SERVICE INFORMATION LETTER

SIL T-060
Revision 2
Page 1 of 7

- DATE: August 21, 2019
1. SUBJECT: AeroLEDs Sunspot 36HX Landing Light Upgrade
 2. MODEL: 480B
 3. EFFECTIVITY: S/N 5136-5239
 4. REFERENCE: Enstrom TH-28/480 Series Illustrated Parts Catalog, Rev. 14 or Later Revision
 5. BACKGROUND:

Figure 1. P/N 01-1030-H-A-P, Rev. C Landing Light

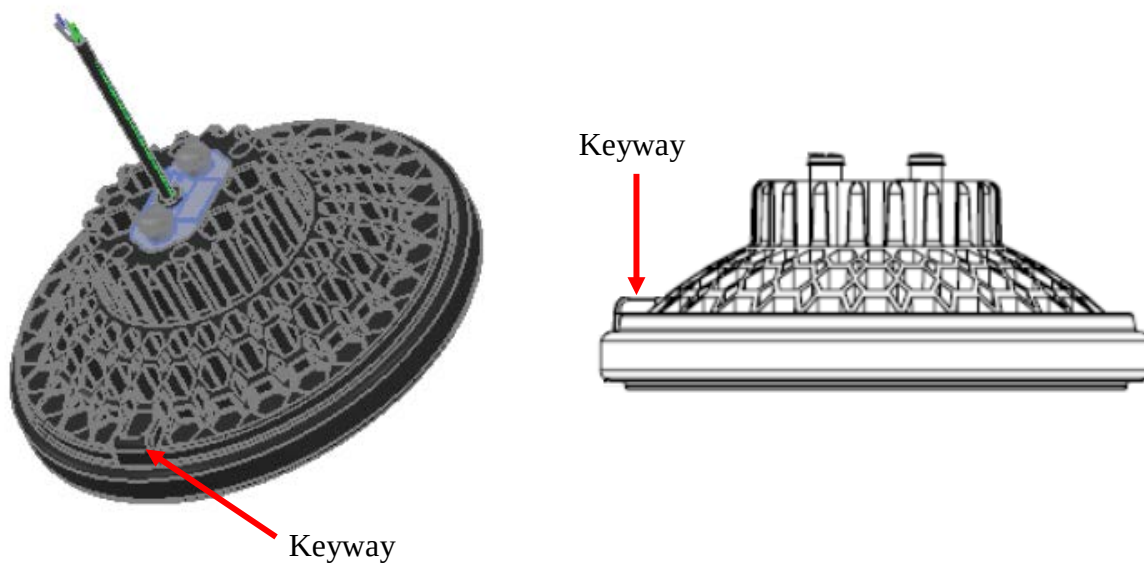
The Rev. C version of the landing light features a keyway (Figure 1) to ensure the light assembly is installed in the proper orientation. If upgrading from a Rev. A or Rev. B landing light assembly to a Rev. C version, the holder plate requires modification to fit the keyway.

The kit includes the landing light assembly, a wire assembly, and a holder assembly to complete the installation. The key characteristics of the new landing light version are a redesign of the electrical attachment to include screw terminals and a slight change in the size of the retention (holder) plate.

Figure 5. Notch Filed in Holder Plate

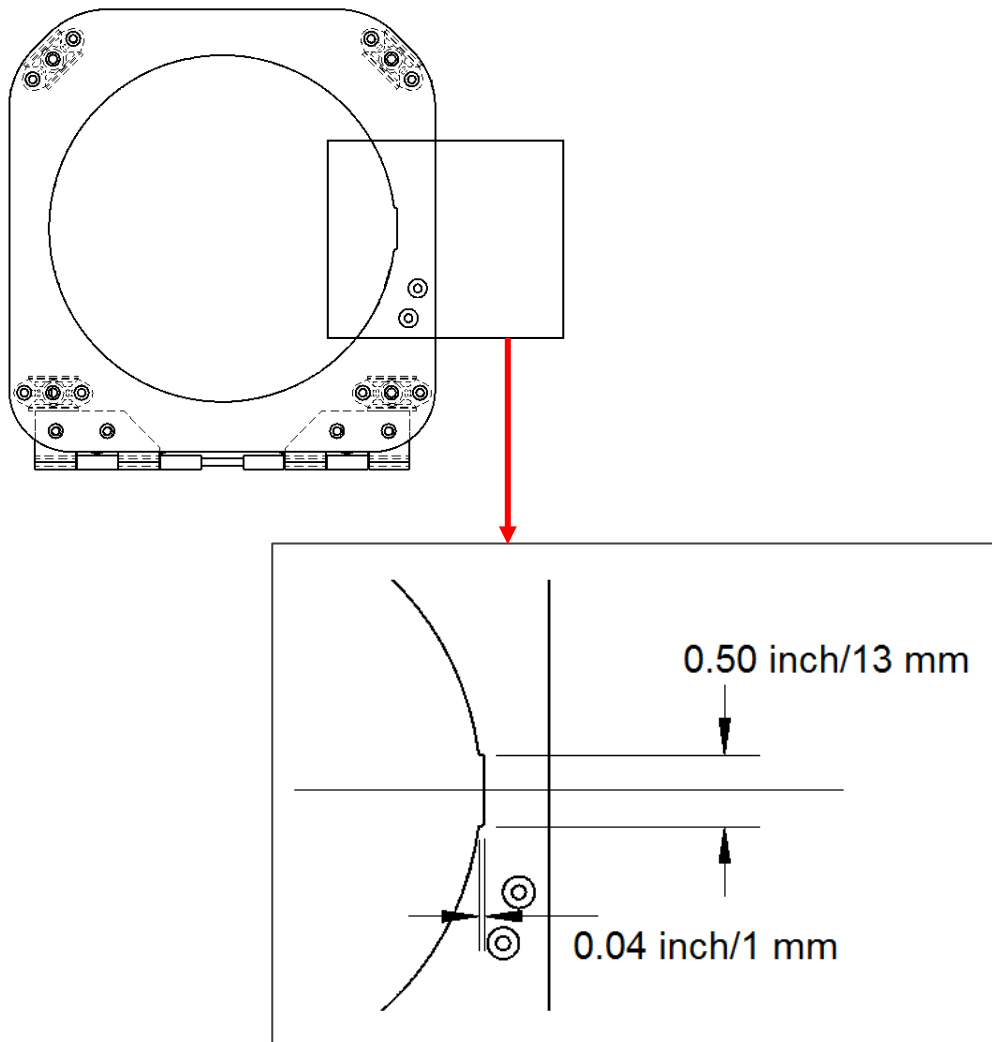
- 6.2.3.1 Using an appropriate size metal file, gently file a notch in the holder plate to the dimensions specified in Figure 5 to accommodate the keyway on the Rev. C assembly.
